SERVICE REQUEST

Request Number: **18181**
Request Type: **Resid Pool Approval**
Associated WO Number:
Date Initiated: 3/17/2011 3:08:39 PM
Submitted To: WALKER, PHILO

APPLICATION FOR RESIDENTIAL POOL CONSTRUCTION

IMPERVIOUS SURVEY OF

PLOT OF SYSTEM

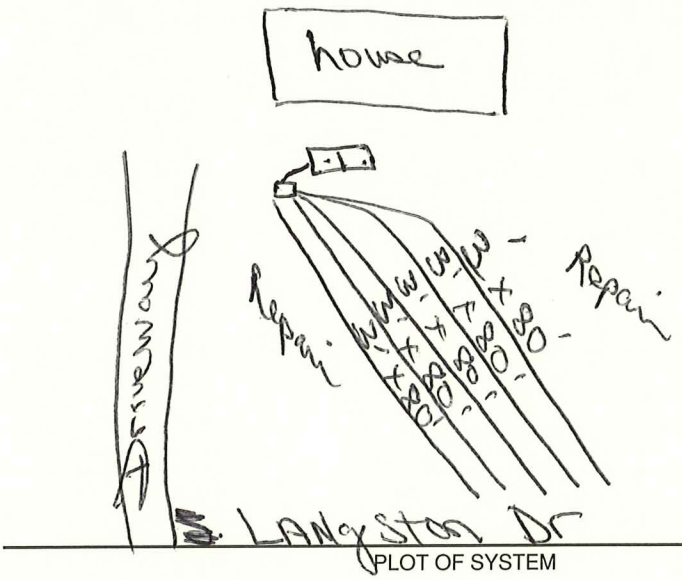
Comments: Install 5 Trenches 3' x 80' x 12" Rock
Run lines on Contour.

CERTIFICATE OF COMPLETION/OPERATION PERMIT

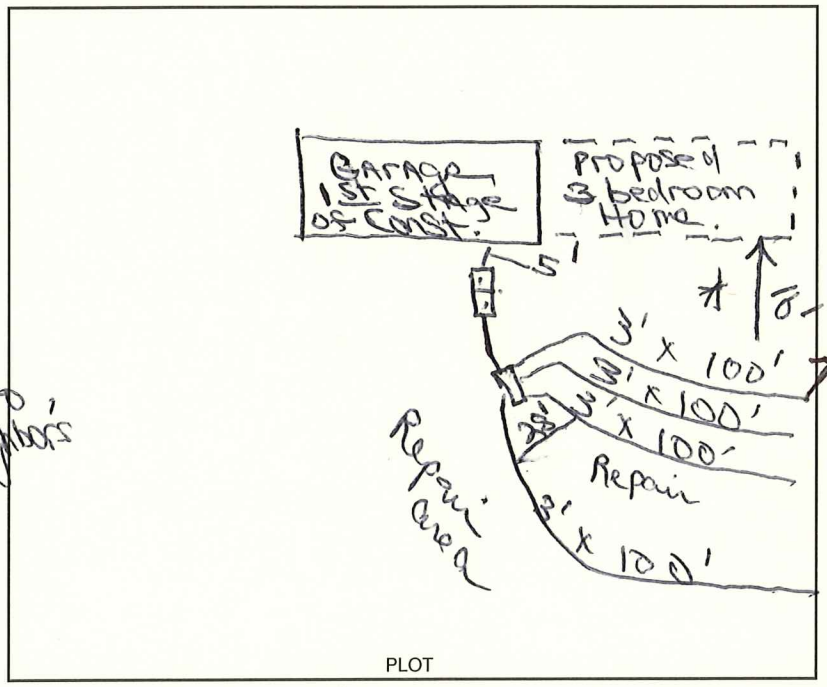
Distance to Water Source >100' 61' to Neighbors

Neighbors Well & Rock

COMMENTS: System designed for 3 bedroom home Type II (a.)
